**January 10, 2017  
Medway Planning and Economic Development Board  
155 Village Street  
Medway, MA 02053**

PROPOSED  
SITE PLAN  
IN  
MEDWAY, MASSACHUSETTS

**RE: MEDWAY GREENS MULTIFAMILY SPECIAL PERMIT/SITE PLAN**

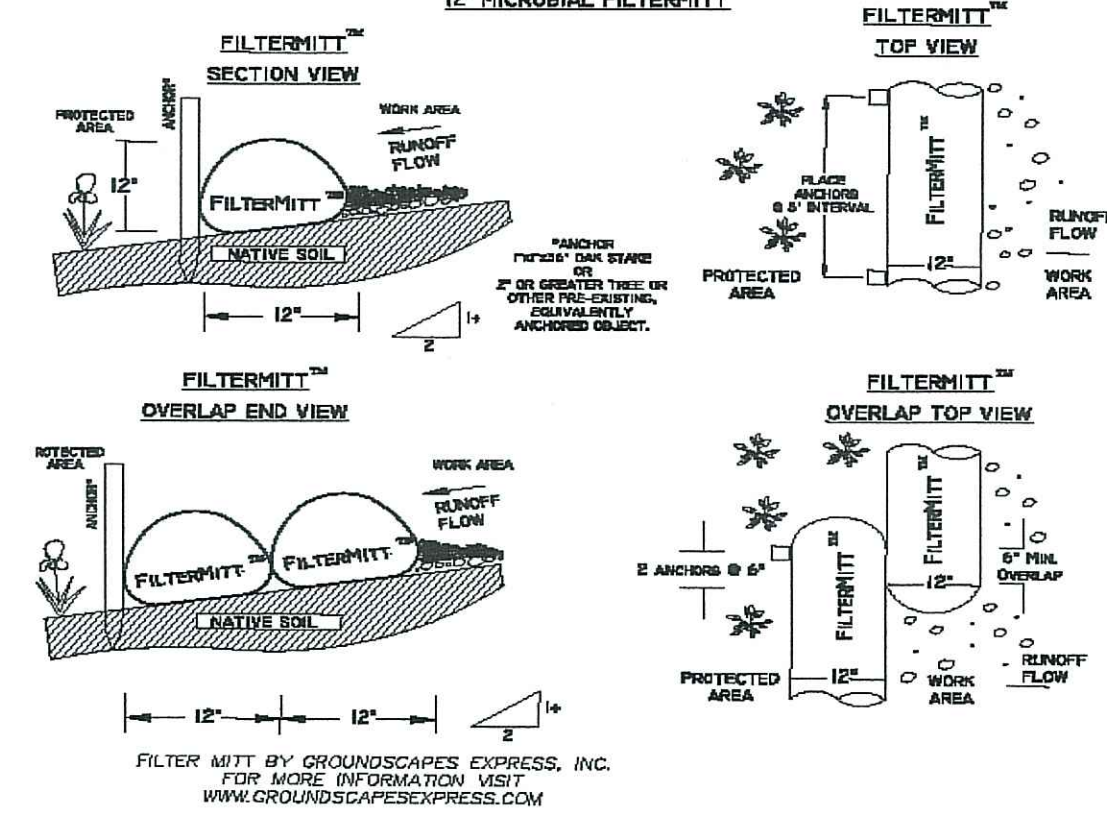
3. The plans show setbacks of 16.3' from Main Street and 15.8' from Mechanic Street. The front setback for the AR-II district is 35 feet. The PEDB has the authority to reduce the setback distance with a 4/5 vote.

- 6) Proposed Site Plan – The Site Plan is generally unreadable and does not provide specific information listed in the standards such as curb radii, curb type or other readable information to allow for a clear review. We recommend the applicant provide a proposed Layout and Materials plan detailing proposed surface finishes and their specific limits and locations.

- 7) Site Grading Plan – A Site Grading Plan is not provided. Grading information is included on the Site Plan but lacks readability and detail necessary to conduct a thorough review. We recommend the applicant provide a Grading and Drainage Plan clearly depicting existing and proposed grades and all existing and proposed drainage-related infrastructure.

- 8) Drainage and Erosion Plan – A Drainage and Erosion Plan is not provided. Some erosion control measures are shown on the Site Plan but lacks the readability and detail to conduct a thorough review. We recommend the applicant include all proposed drainage improvements on the Grading and Drainage Plan and show all proposed erosion control measures and demolition on the Existing Conditions Plan.

- 18) A detail of the proposed stone walls on site has not been provided. Walls are proposed nearly coincident with proposed erosion controls along the Main Street property boundary. We question whether the proposed erosion control can be maintained in that area during construction to mitigate any potential washout of site soils onto Main Street during storm events.

LANDSCAPE  
PLAN

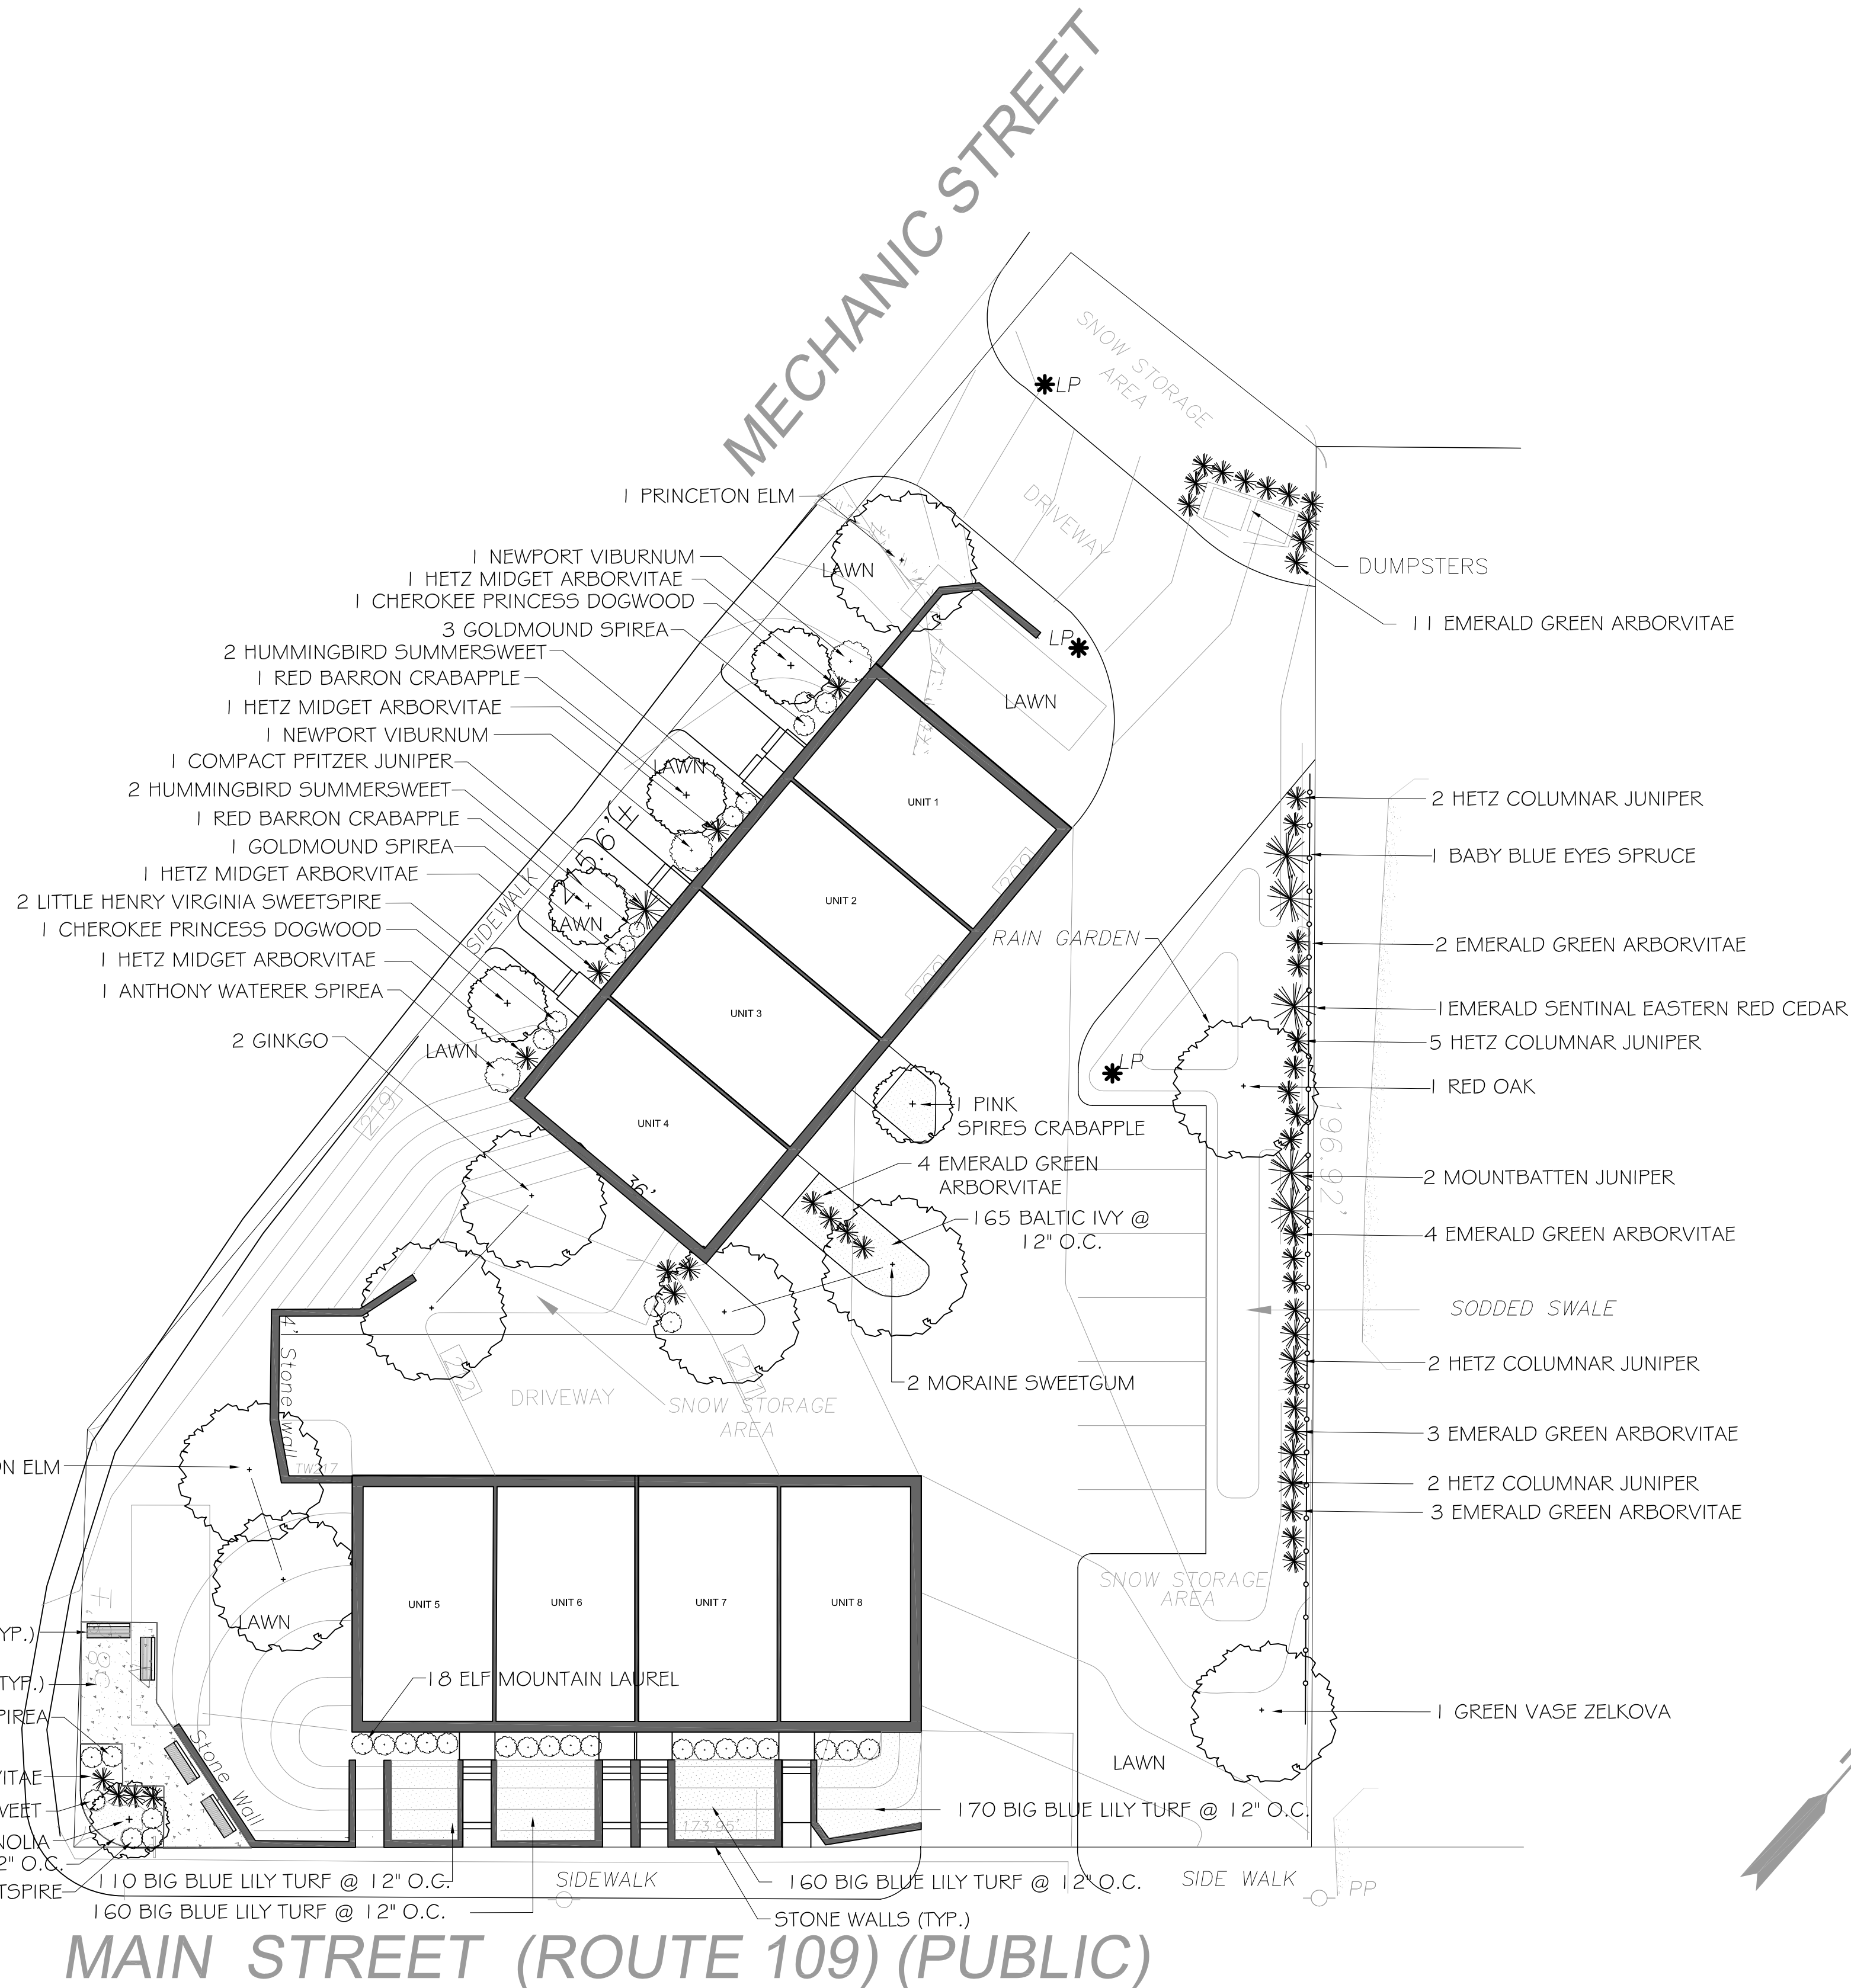
7. Section 504-4 C of the AUOD standards require that parking be to the side or rear and that it be screened from the public way. The project meets this requirement but may need additional screening as the Landscape Plan shows a single tree and a grass area between the parking area and Main Street. Provision has been made for future linking to adjacent property as required. Also, there are 2 spaces per unit (1 garage space and 1 exterior space).

19. Section 205-9 provides standards for trees and landscaping. Parking lots are required to have 1 tree per 6 spaces, and only trees that shade parking spaces are counted for this requirement. In this instance, 3 trees are required, though only 8 of the spaces are outside so 2 may be sufficient. Seven trees are provided around the perimeter of the access drives and parking lot, but only 2 provide shade to a parking space (and the same space - #8) as required.
